**Land West of Teynham (21/503906)
and Land South and East of
Sittingbourne (21/503914): Transport
and Highways Review**

client: Teynham, Doddington, Lynsted with
Kingsdown and Tonge Parish Councils

Railton TPC Ltd

| Date: | June 2024 |

Plan 5.1: National Cycle Network Route 1

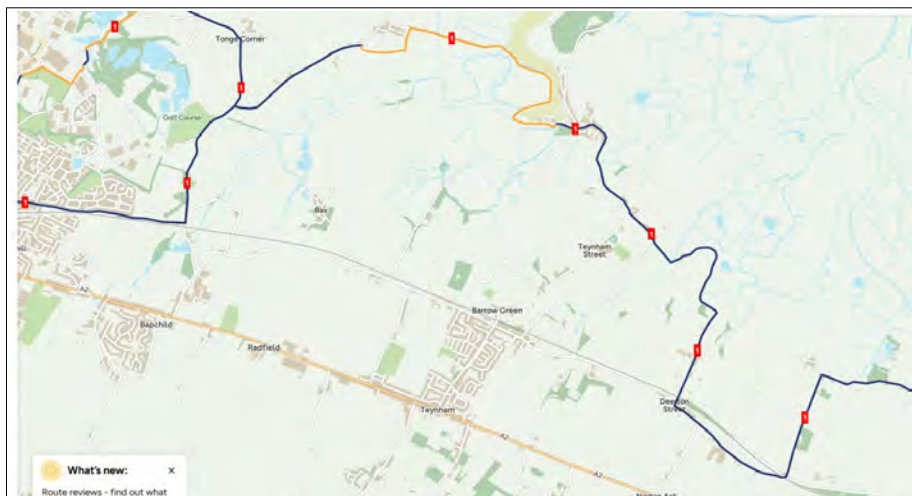
- 5.18 NCN1 does not currently function as a direct and convenient east-west route. There are no alternative recommended east-west cycle routes passing the site identified on the Explore Kent map of walking and cycling routes. At present neither Sustrans (NCN routes) nor Kent County Council identify any cycle routes in the vicinity of the site that could assist cyclists in accessing either Sittingbourne or Faversham. Lower Road would constitute a convenient and largely flat route east-west between Sittingbourne and Faversham, a realistic alternative to using the A2 that is congested in places, carries significant numbers of HGVs and has sections where vehicles travel at relatively high speeds. Some cyclists already choose to use Lower Road rather than negotiate the A2 or the longer detour route to the north. Existing and possible new cyclists would not, however, be able to safely use Lower Road if it were to continue to carry fast moving rat-running traffic at current or elevated levels in the future.

Plan 6.1: Kent Science Park South Junction (extract from Drg. No. 16-023/2011D)

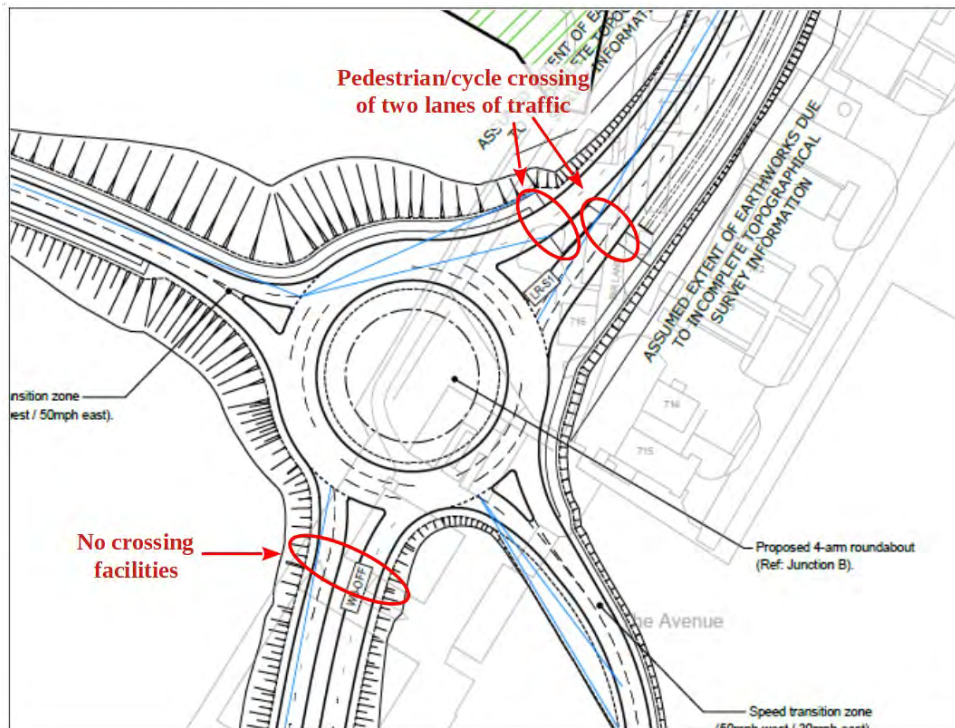
- 6.5 Kent Science Park lies to the east of the SSRR in this area and most of Highsted Village lies to the west. No crossing facilities are provided to the south of the junction and none to the north until the Commercial Access to Highsted Road (see below). All pedestrians and cyclists would be required to use the uncontrolled crossing points of the north and southbound dual-carriageway arms of the junction. Crossing two lanes of potentially fast moving traffic at roundabout entries and exits is highly threatening for even the most able bodied and confident pedestrian. The crossings would represent a significant barrier to sustainable travel and would be unusable or highly dangerous for vulnerable groups.

Plan 6.2: Commercial Access Junction to Highsted Road

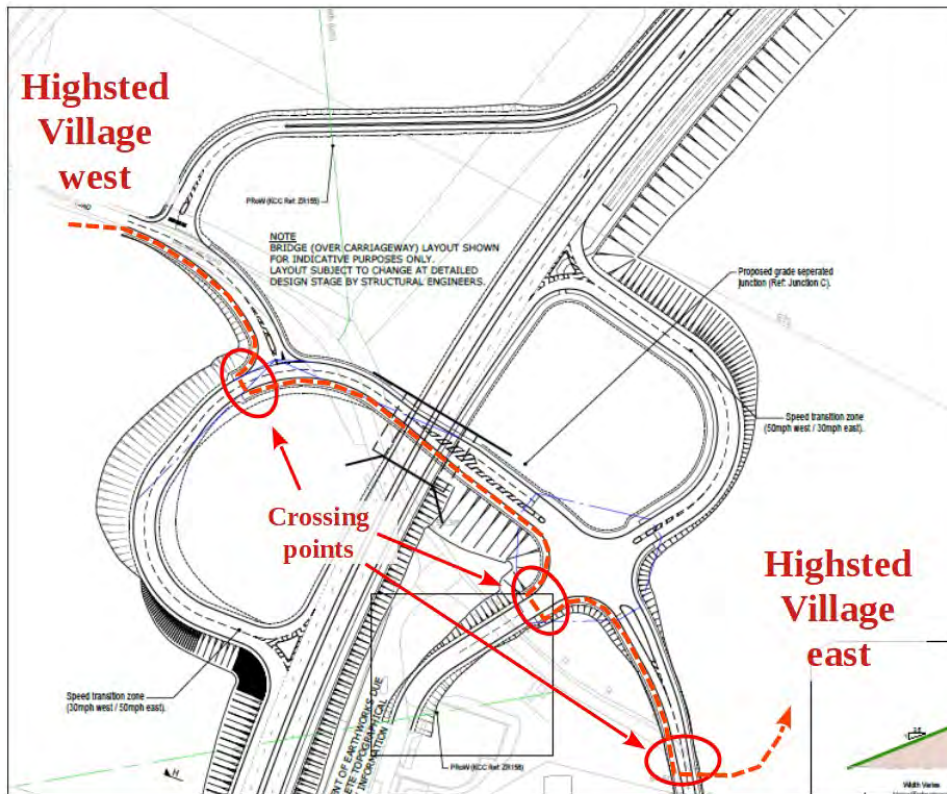
- 6.7 Parts of Highsted Village are located to the east and west of the SSRR. Although the supporting information refers to the bridge over the SSRR as a 'green bridge' it does not function as a convenient and direct route for pedestrians and cyclists. Although pedestrians and cyclists may, with the redesign of the bridge, have a segregated route crossing over the SSRR, there are then three road crossing points to negotiate. A genuine 'green' route would provide direct and convenient pedestrian and cycle access without having to negotiate the complicated road layout. The junction is essentially designed to provide high vehicle capacity with the potentially widened bridge an afterthought (and not even shown on the drawing).

Plan 6.3: Highsted Road Junction

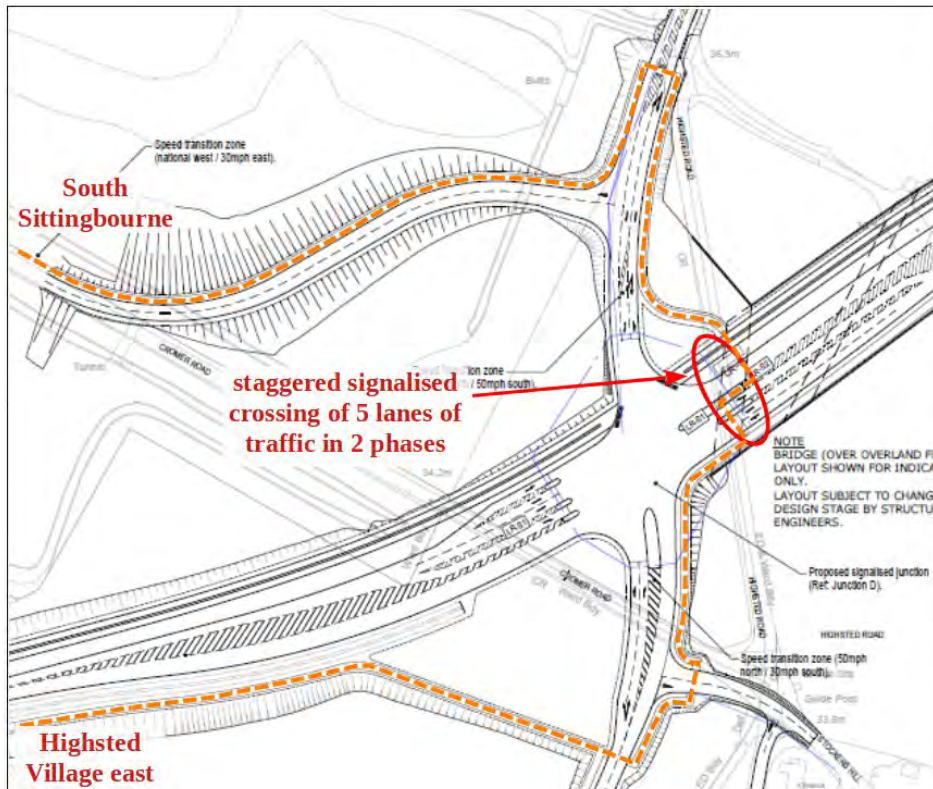
- 6.11 The route shown in orange for cyclists between south Sittingbourne and Highsted Village east illustrates the priority given to vehicles at this junction and the limited and convoluted routes available for sustainable modes.
- 6.12 Pedestrians and cyclists are also faced with significant waits at the SSRR since they are forced to cross in two stages.
- 6.13 No further crossing points of the SSRR are proposed between this junction and the roundabout junction at the south of Oakwood Village (Church Street junction).
- 6.14 It is noted that the operational assessments of this junction are missing from Appendix E of the TA Vol. 7. It is therefore impossible to assess what assumptions have been made about the frequency of use of the pedestrian facilities and impossible to assess the

Plan 6.4: Access to Development East of Highsted Road

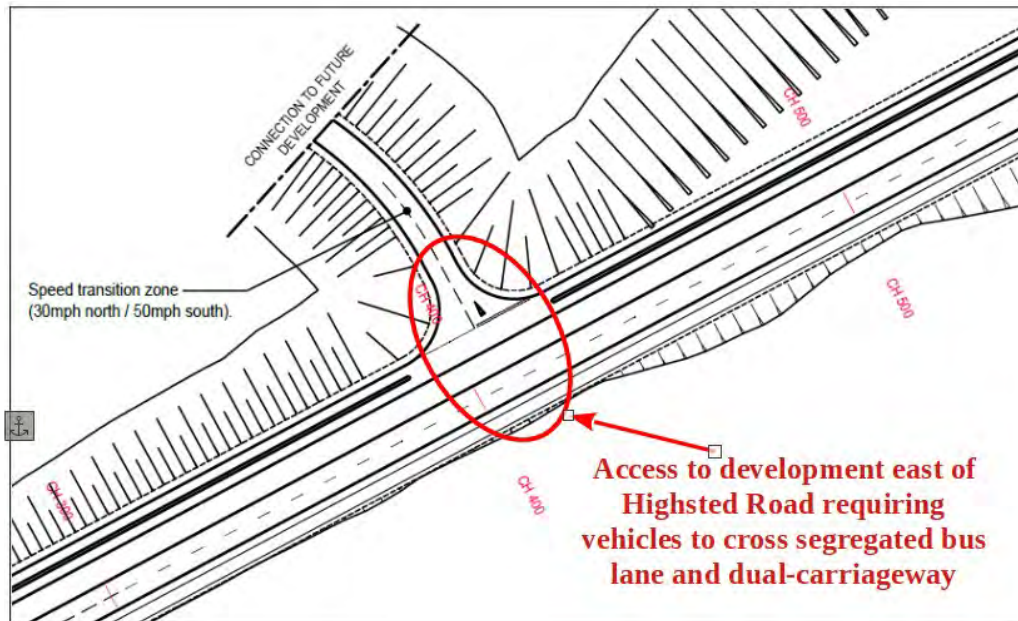
- 6.16 The junction as shown would not be acceptable. This aspect of the overall access strategy has not been thought through. It is proposed to limit the use of the northern section of Highsted Road to buses and cyclists (see Figure 6.2 of TA Volume 5). General vehicle access therefore needs to be to and from the south either via the Highsted Road junction or Cromer Road to access Sittingbourne directly. If there is to be another junction in the location shown above it is necessary to demonstrate that it can operate safely and satisfactorily.

Plan 6.5: Church Street Junction

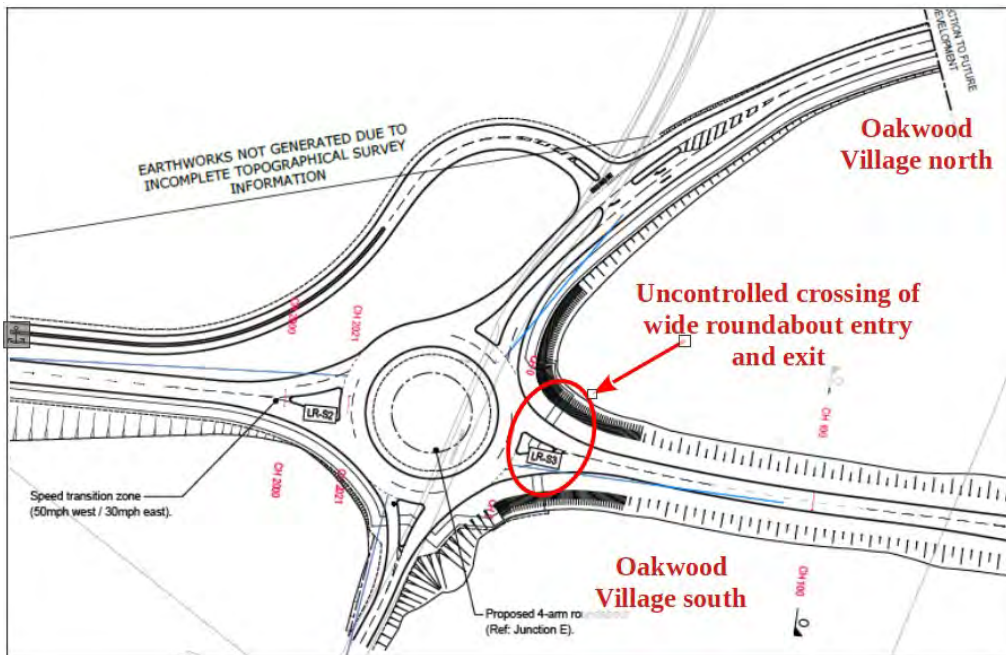
- 6.18 In order to travel between Oakwood Village north and south it would be necessary to negotiate uncontrolled crossing points at a two-lane westbound roundabout entry and a wide roundabout eastbound exit. This arrangement would represent a significant barrier to sustainable travel and would be highly dangerous for vulnerable highway users.

Plan 6.6: Oakwood North Junction

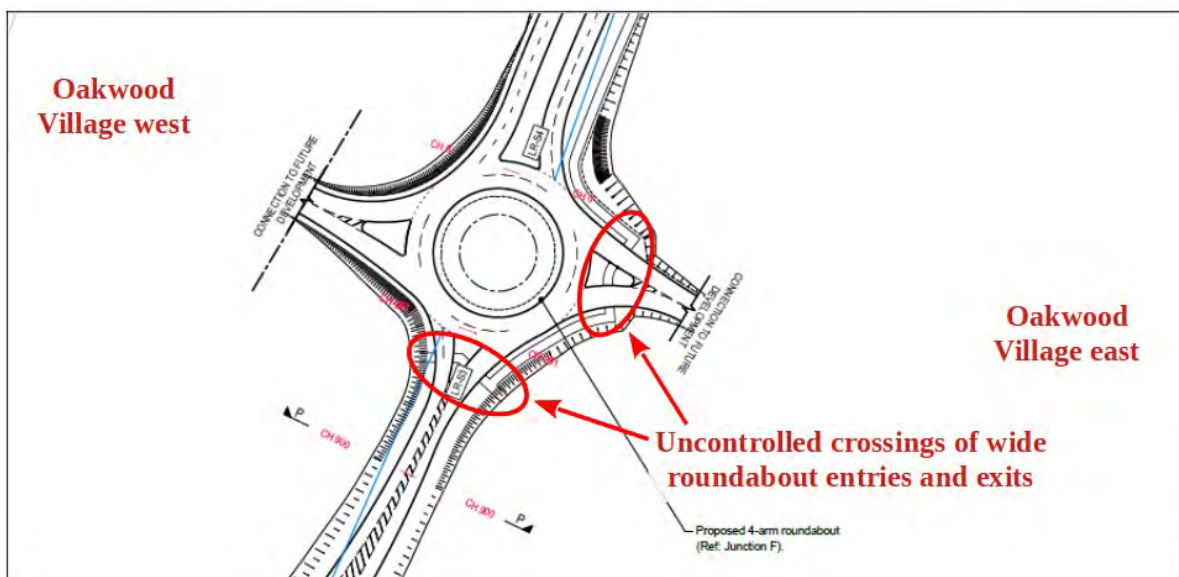
- 6.20 The proposed arrangement provides priority to vehicles and makes pedestrian and cycle movements both difficult and hazardous where uncontrolled crossing facilities are provided close to roundabout entries and exits.

Plan 6.7: A2 Junction

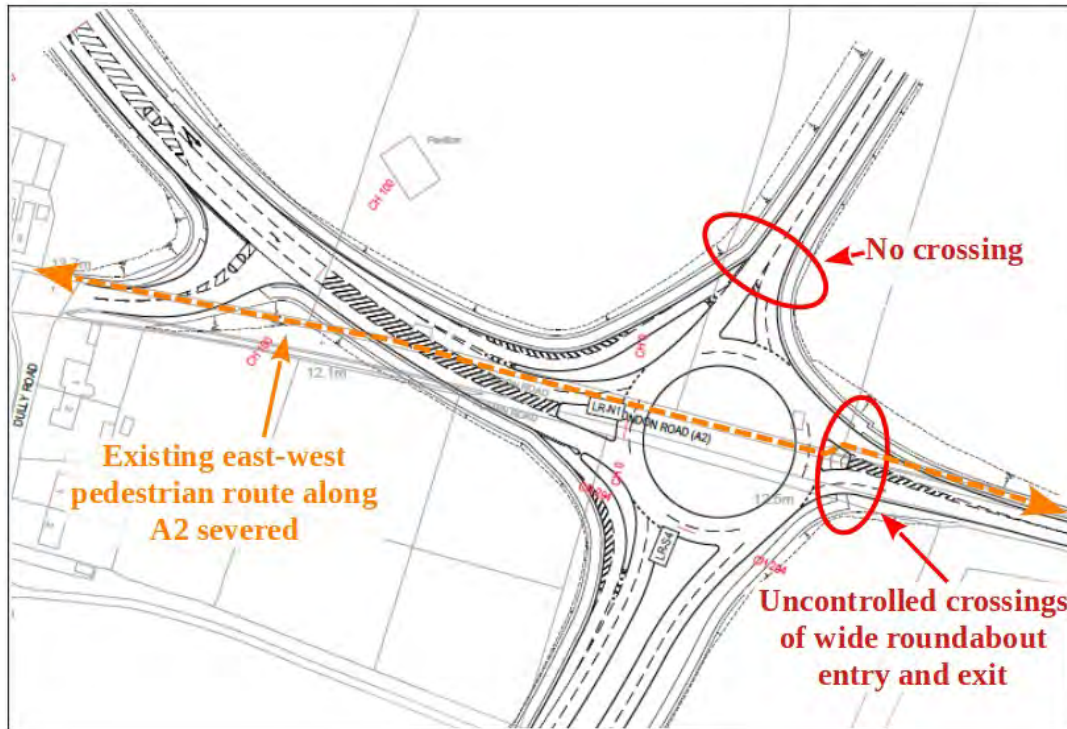
- 6.22 North-south movements on foot and by bicycle are made very difficult and dangerous by the introduction of the uncontrolled crossings on the eastern side of the roundabout. This arrangement introduces a significant level of severance between the northern and southern parts of the proposed development. Access to Teynham railway station, for example, is made difficult for those on foot and using bicycles travelling between the station and development south of the A2. New residents living north of the A2 would find it almost impossible to access, on foot, the proposed new school located to the south-west of the roundabout.
- 6.23 The existing pedestrian footway route that follows the northern side of the A2 is entirely severed as it becomes impossible to travel east-west without crossing roads that are not provided with designated facilities.

Plan 6.8: Public Rights of Way south of Swanstree Avenue

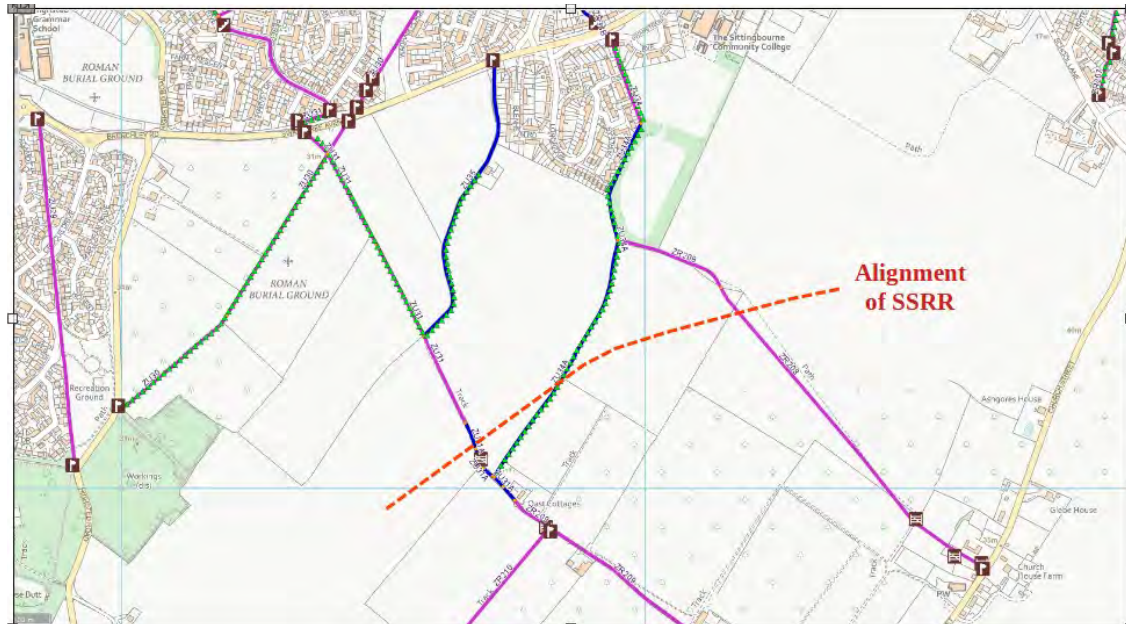
- 6.31 The plan shows that the SSRR crosses all three of these PROWs. The existing rights of way provide the most direct walking routes between villages to the south of Sittingbourne and key facilities within the town such as the secondary school on Swanstree Avenue. The following plan extracted from the TA Vol. 6 shows in more detail the proposed SSRR in this area:

Plan 6.9: SSRR Severing Public Rights of Way

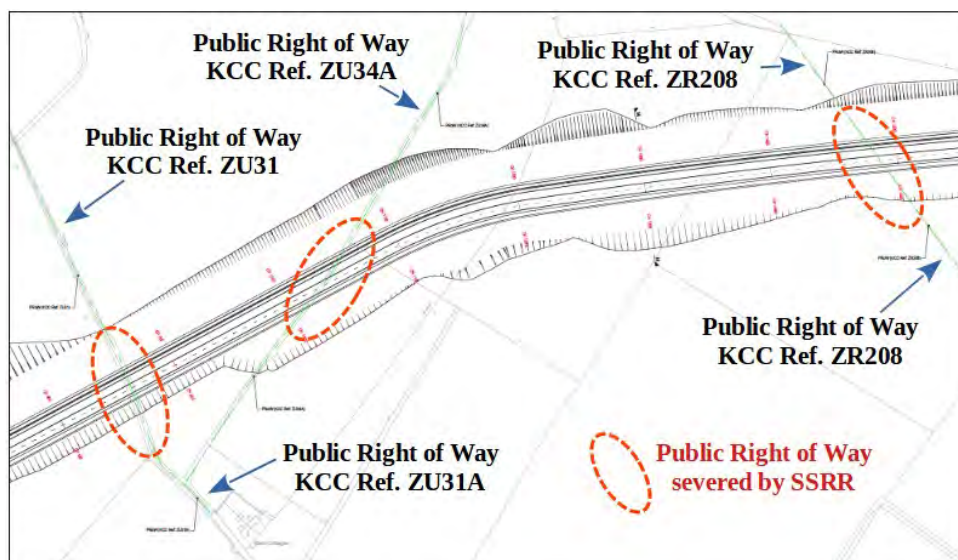
- 6.32 There is no mention of how these existing PROWs will be maintained in either the TA Volume 5 Sustainable Transport Strategy or the Transport Chapter of the ES Main Text. The work undertaken to date suggests that the proposals will have a significant adverse impact in terms of severance in this area yet the issue has been entirely ignored.

Plan 6.10: Proposed Bus Services

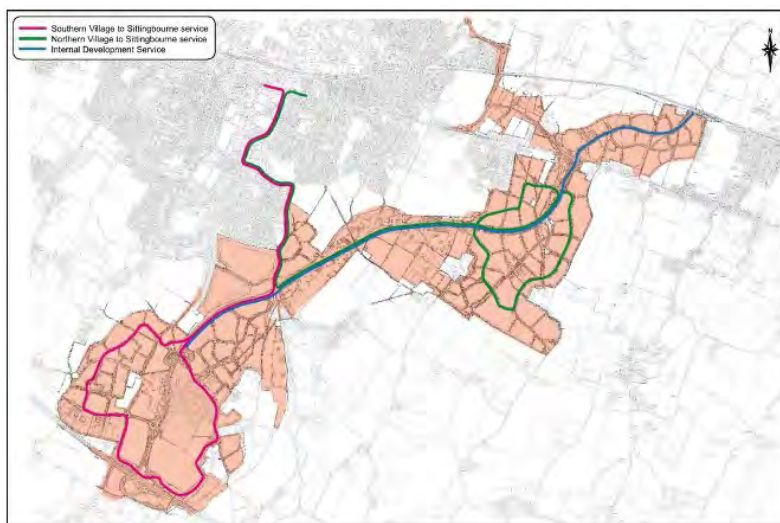
- 6.37 The necessity for a number of routes to provide reasonable service 'coverage' and the 'one-way loop' problem will inevitably reduce the potential to provide frequent services. The CIHT document, 'Buses in Urban Developments' (CIHT, January 2018) examines the relationship between the frequency of bus services and the distance that people are prepared to walk to them¹⁶. The standard assumption of a maximum 400m walk to bus stops is recommended when the frequency of service is 5 per hour or better. When less frequent services are provided the recommended walk distance reduces to 300m. The need to provide multiple bus services will inevitably reduce the frequency at which a viable service can continue. People will be less inclined to walk to infrequent services and overall patronage would fall further undermining the viability of services.

Plan 6.11: Development Zones

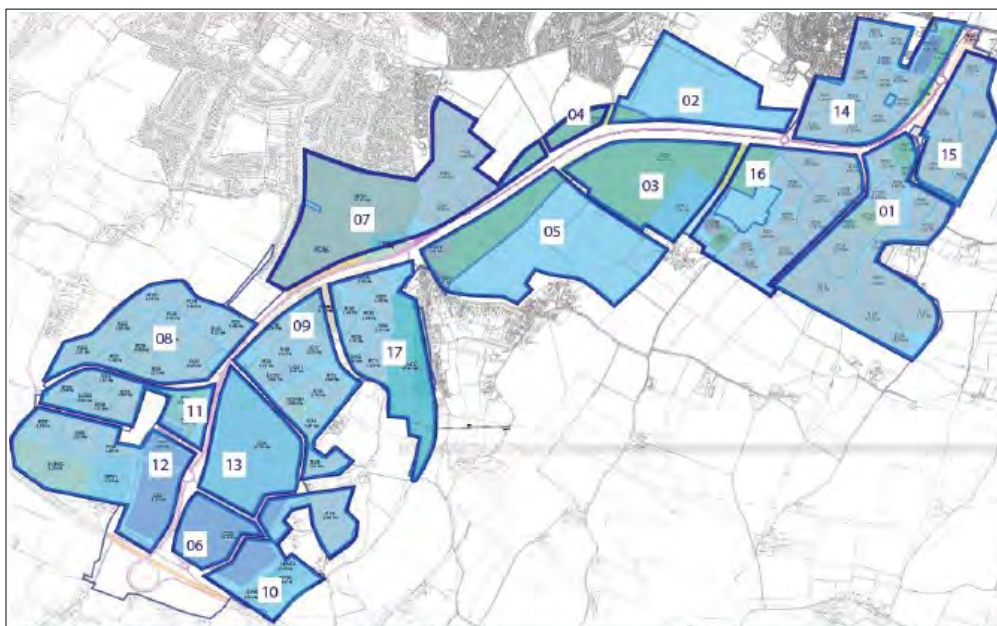
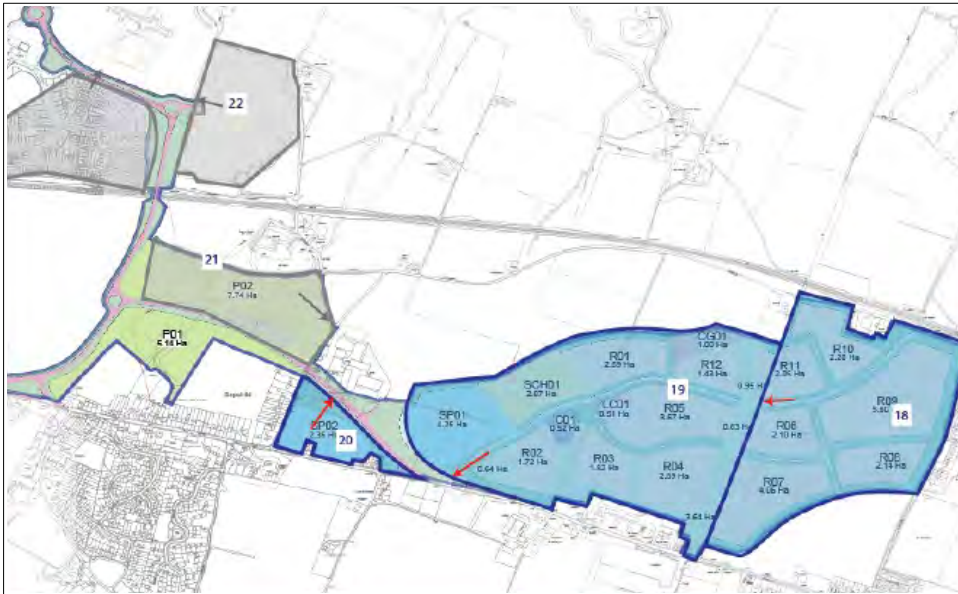
- Table 3.5 assigns all secondary school trips to Zone 12 (just north of M2 Junction) yet Table 3.6 allocates secondary school arrivals to Zone 15 (just south of A2 junction). The latest Parameter Plan for Oakwood Village (Drg. No. 2782-475P) shows the secondary school located south of the A2 but west of the SSRR in Zone 14;
